SUBJECT: NEW RIFLE, COLORADO, PROCESSING SITE – REQUEST FOR  
ADDITIONAL INFORMATION RE: DRAFT GROUNDWATER COMPLIANCE  
ACTION PLAN

Docket No.: WM-00062

**REQUEST FOR ADDITIONAL INFORMATION**  
**DRAFT GROUNDWATER COMPLIANCE ACTION PLAN**  
**NEW RIFLE, COLORADO, PROCESSING SITE**  
**DOCKET NO. WM-00062**

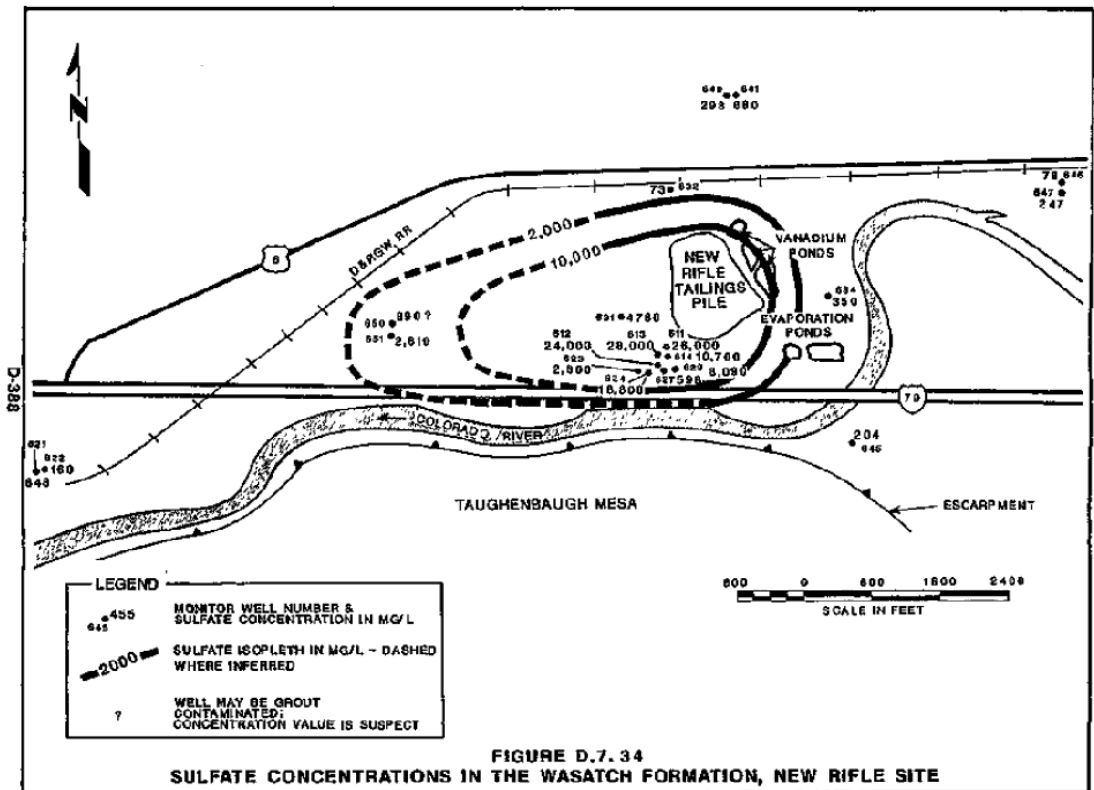
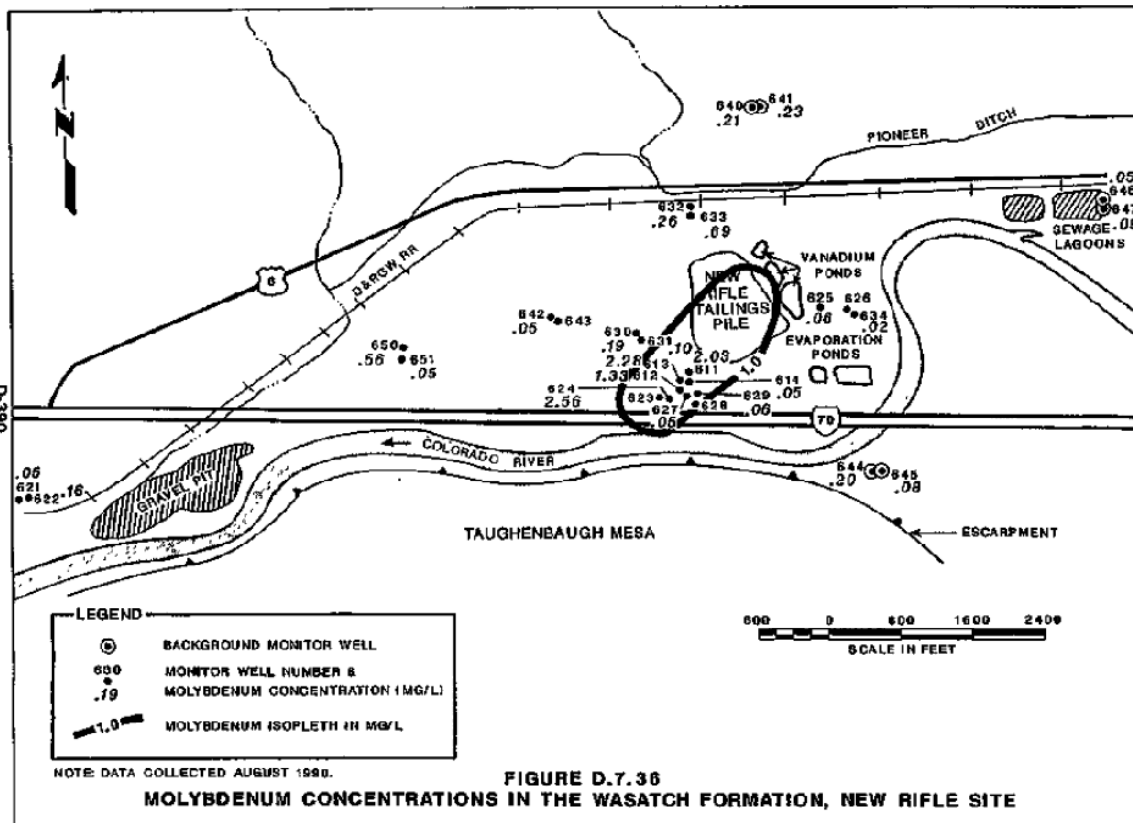
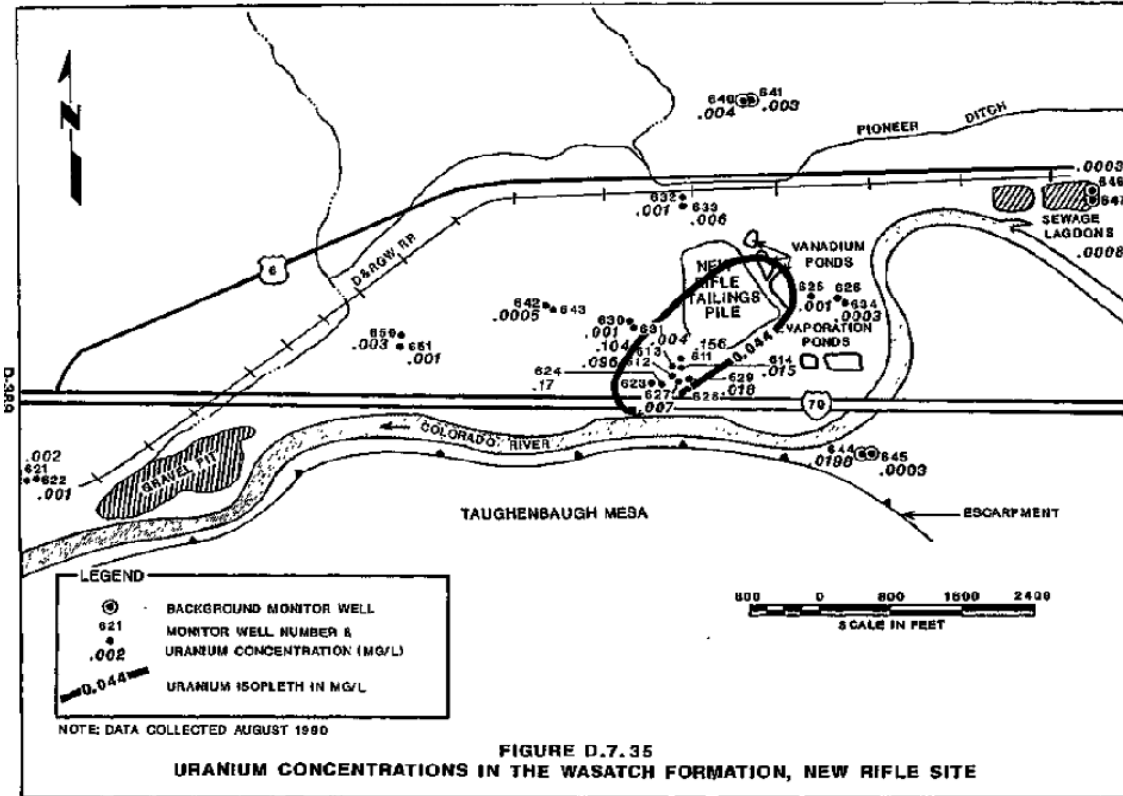
**Comment 7:** DOE indicated that site field investigations have shown that the alluvial aquifer is the only aquifer affected by the former milling operations (page 15). This conclusion seems to contradict previous characterization data.

**Basis:** Data from DOE's 1992 remedial action plan (Reference 2) shows contamination of the Wasatch formation by a variety of COC's. That document indicates that groundwater was contaminated to depths of 27 m [90 ft] and distances of 1100 m [3500 ft]. The figures below provide isopleths for sulfate, uranium, and molybdenum. In the case of uranium and molybdenum, it appears there is limited characterization data to estimate contaminant concentrations south of interstate 70 from the previous location of the tailings pile. The closest well is 0217, which showed the second highest uranium value in the alluvium [0.13 mg/L] as of November 2015 in Figure B-2 of the draft GCAP. DOE indicated that the Shire Member (uppermost layer of the Wasatch Formation) is hydraulically connected to the overlying alluvium though flow is not dominant from one unit to the other. During milling operations, very large quantities of water were used compared to the present day, which may confound the development of a conceptual model to describe the extent of groundwater contamination. High water usage may have driven contamination much deeper in the system than would be anticipated by present day hydrologic measurements.

**Path Forward:** Provide a description of monitoring data collected for the Shire and Molina Members of the Wasatch Formation. Reconcile the characterization data presented in the 1992 remedial action plan with the present day GCAP summary. If necessary, revise the monitoring network, and POE locations and analysis to account for contamination of the Wasatch Formation.
